December 15, 1999
NTSS00-24/LEF

SUBJECT: Memo report on Final Draft Report, "Reexamination of NUREG-0170 Spent Fuel Shipment Risk, Estimates"

Comments on Final Draft Report

**Re-examination of NUREG-0170
Spent Fuel Shipment Risk Estimates**

Figure 1 Creep-Rupture Data for Stainless Steel and Zircaloy Tubing.

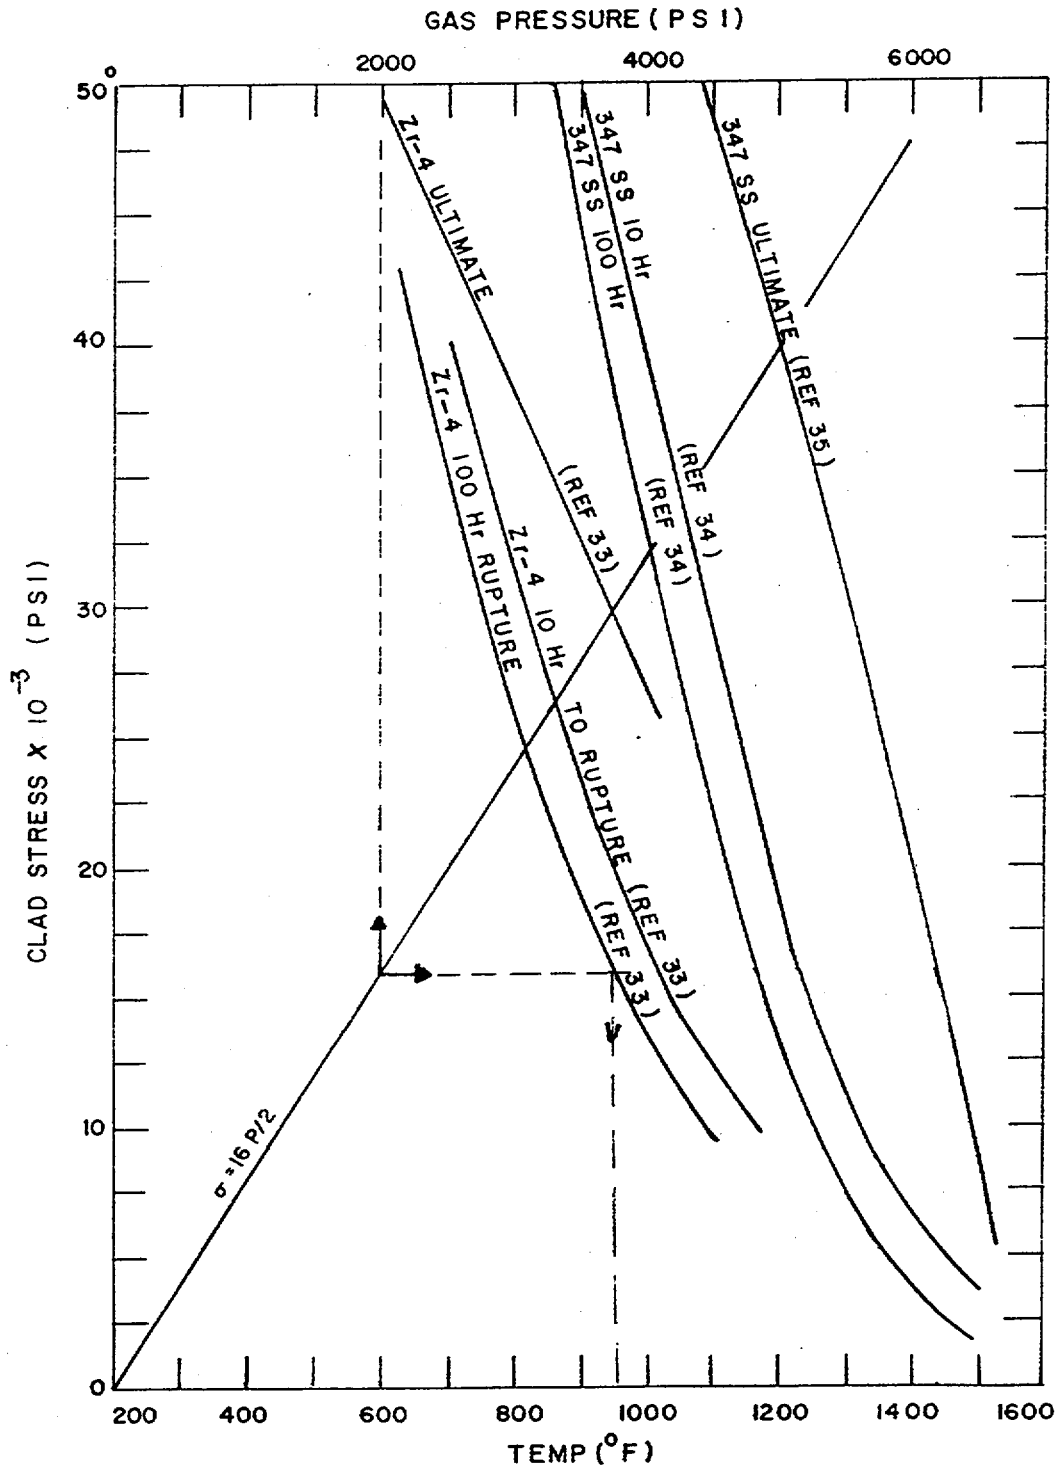
The temperature of the fuel rods is estimated using the inner wall temperature of 215°C (Table 6.4). The temperature increase from the cask inner wall to the central four assemblies is estimated using reference 5 (p.136-140). The temperature increase to the four fuel assemblies with 852 watt average heat load for all assemblies in cask is $210-90 = 120^{\circ}\text{C}$. For an increased heat load from 852 W to 2796 W (Table 6.3) the temperature increase is $120 \times 2796/952 = 393^{\circ}\text{C}$. However, the higher temperatures for the hotter assemblies will increase the effective thermal conductivity by $\sim 4/3$ resulting in an estimated temperature for the four center assemblies $T = 393 (3/4) + 215 = 510^{\circ}\text{C}$ (950°F).

At the end of life the pressure in a fuel rod is near but below the PWR operating pressure of 2000 psi and is estimated to be 1600-1800 psi at 600°F. The rod

pressure at 950°F will be ~ 2000 psi. As shown in Figure 1, the rod will likely rupture after 100 hours of creep at 950°F [6].

The SNL Study significantly underestimates the temperatures of the fuel rods, hence their time of failure, radioactive material releases, and the associated risks. As recommended at the July 29 meeting, the fuel burnup/cooling times should be specified such that the fuel assembly heat load is ≤ 1 kW so that the fuel rod temperatures are more realistic and the fuel failure rates are more reasonable.

Figure 2. Pressure vs. Log[Time]

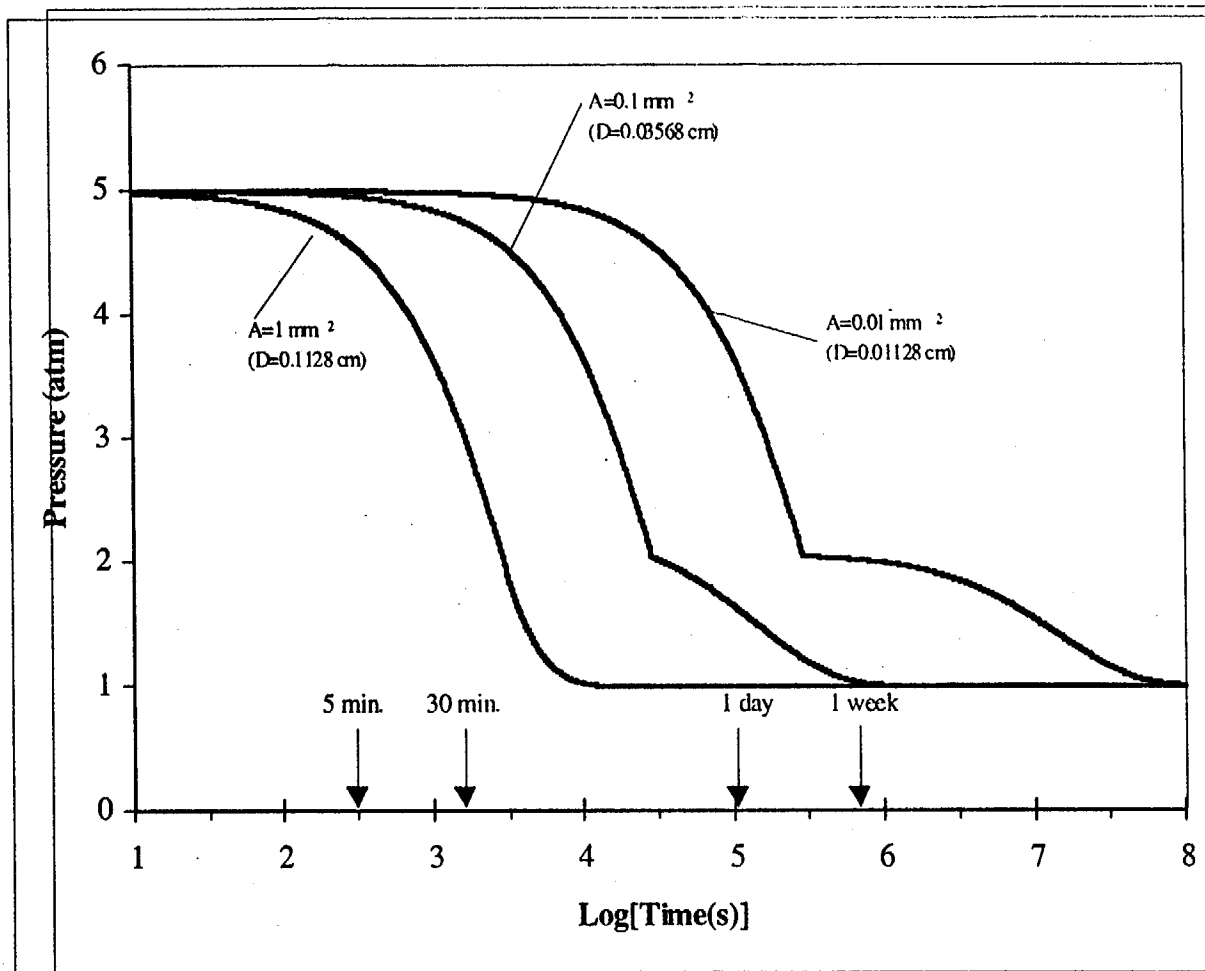
For a 1 mm² leak hole in a containment vessel initially at 5 atm with helium fill gas at an average temperature of 640° K, our analysis indicates that it takes about 30 minutes for the cask to depressurize to near ambient pressure. This result agrees with the MELCORE calculations given in the report for the time to depressurize a rail cask. The initial leakage rate for this depressurization is over 800 cc/s. For comparison, ANSI N14.5 considers a leak of 0.1 cc/s to be a large leak.

We also performed analyses on the time to depressurize a rail cask for leakage holes with cross-sectional areas of 0.1 mm² and 0.01 mm². When the leak hole area is 0.1 mm² the cask takes less than 9 hours to depressurize, and when the

leak hole area is 0.01 mm^2 the cask takes less than 4 days to depressurize. (See Figure 2.) The leakage rates for these two cases are 80 cc/s and 8 cc/s , respectively which are significantly higher than $.1 \text{ cc/s}$.

From these analyses it is clear that the hole sizes less than 1 mm should be evaluated for leakage flows and radioactive material releases or the radioactive material releases and associated risks will be significantly underestimated.

Figure 3. A₂'s Released vs. Log[Time]

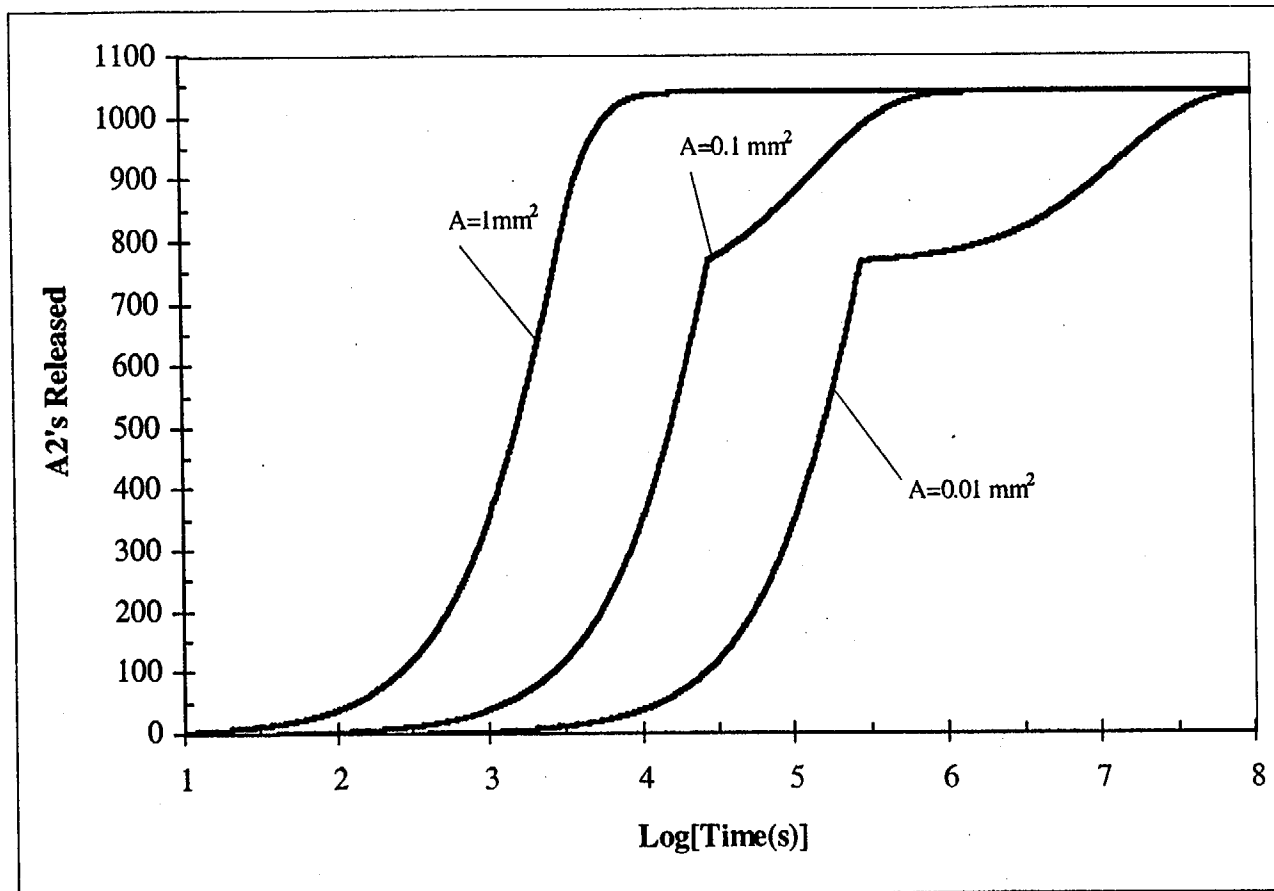
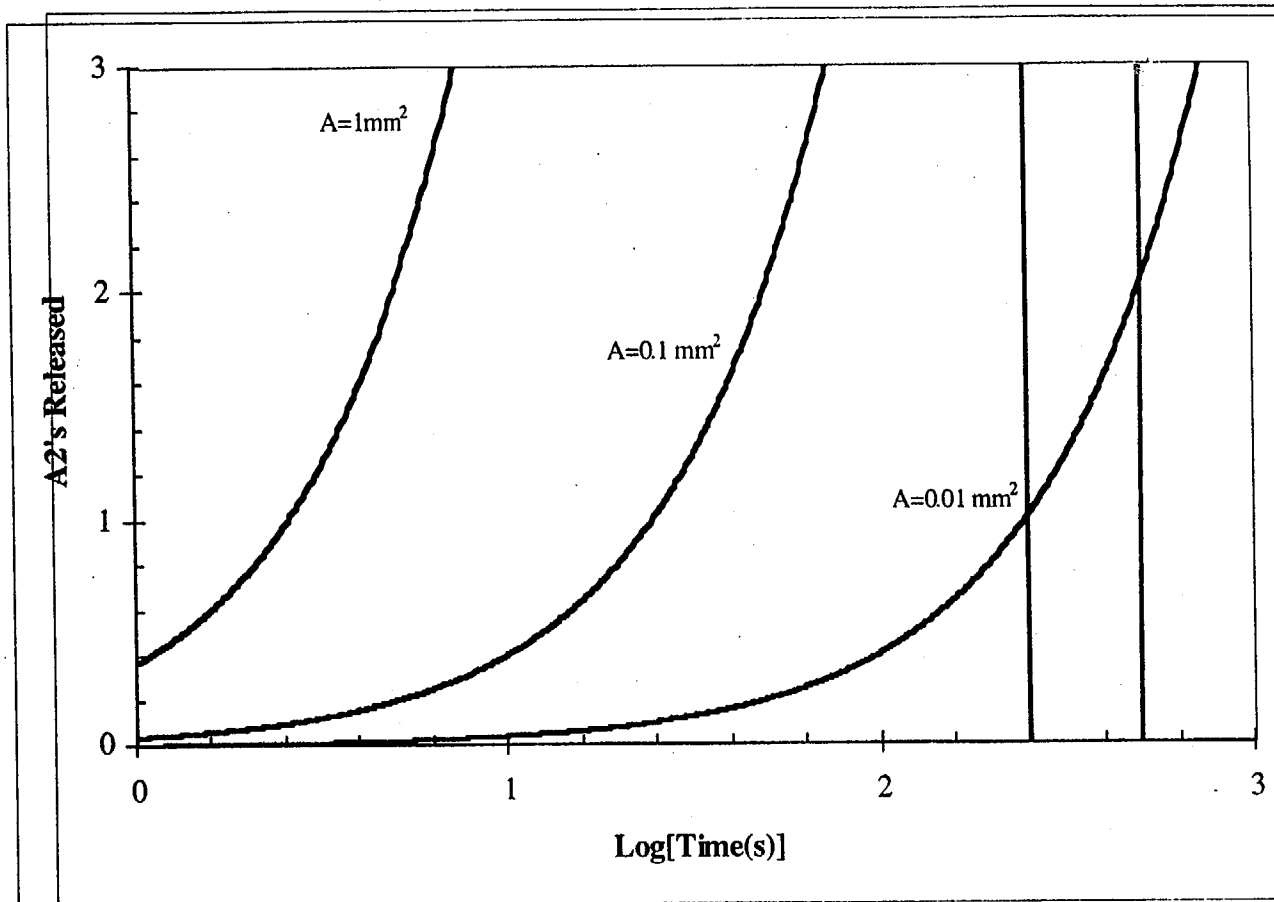
An analysis was performed to determine the number of A_2 's released from a rail cask holding 24 spent fuel assemblies for various leakage hole diameters. From NUREG/CR-6487^[6], the releasable source term for a rail cask holding 24 spent fuel PWR assemblies would have a total activity of 28,982 Ci. With an effective A_2 for the releasable source term for PWR spent fuel under hypothetical accident conditions of 27.9 Ci, the releasable source term in the cask is equivalent to about 1040 A_2 's. Using the following parameters, the number of A_2 's released, as a function of time for a rail cask is calculated for various leakage hole diameters: $T=640 \text{ K}$, Molecular weight of fill gas = 4 g/gmol , viscosity of fill gas = 0.031 cP , volume = $2.68 \times 10^6 \text{ cc}$, and leakage path length = 10 cm . The results for the number of A_2 's released as a function of time are shown in Figure 3. From Figure 3, it is clear that for the case when the leakage hole has an area of 1 mm^2 , there are almost 400 A_2 's released in less than 17 minutes. For hypothetical accident conditions, it is useful to determine the time that it takes to release one A_2 of releasable material. Figure 4 shows the relevant region of Figure 3 to make this determination. From Figure 4, we see that the cask with a leak hole of 1 mm^2 an A_2 of materials is released in less than 10 seconds. For a cask with a leakage hole with an area of 0.1 mm^2 it takes less than 100 seconds to release an A_2 , and for the cask with a leakage hole with an area of 0.01 mm^2 it takes less than 1000 seconds (17 minutes).
